# Access Compliance Report Public Rights-of-Way (Curb Ramps)

Main Street: ROSSMOOR\_WAY Cross Street: WEATHERBY\_RD Location: NW

ADA ID: RPRK211217131734 Ramp Type: Type 1 - Perpendicular Diagonal Initial Pass/Fail: Pass Overall Compliance: No Severity Score: 9

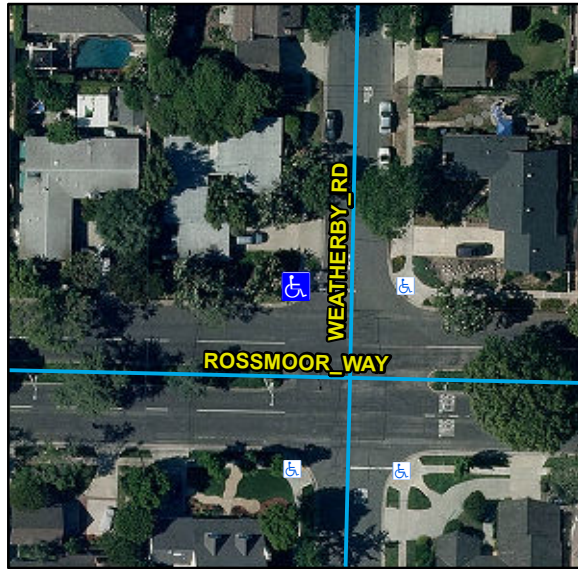
| Compliance | Description                           | Data | Compliance | Description                   | Data   |
|------------|---------------------------------------|------|------------|-------------------------------|--------|
| No         | Gutter Run Slope (%)                  | 6.3  |            | Road Cross Slope (%)          | 5.8    |

Remove & Replace Landing. Remove & Replace Gutter.

R304.2.1, R304.5.4, STD 1115
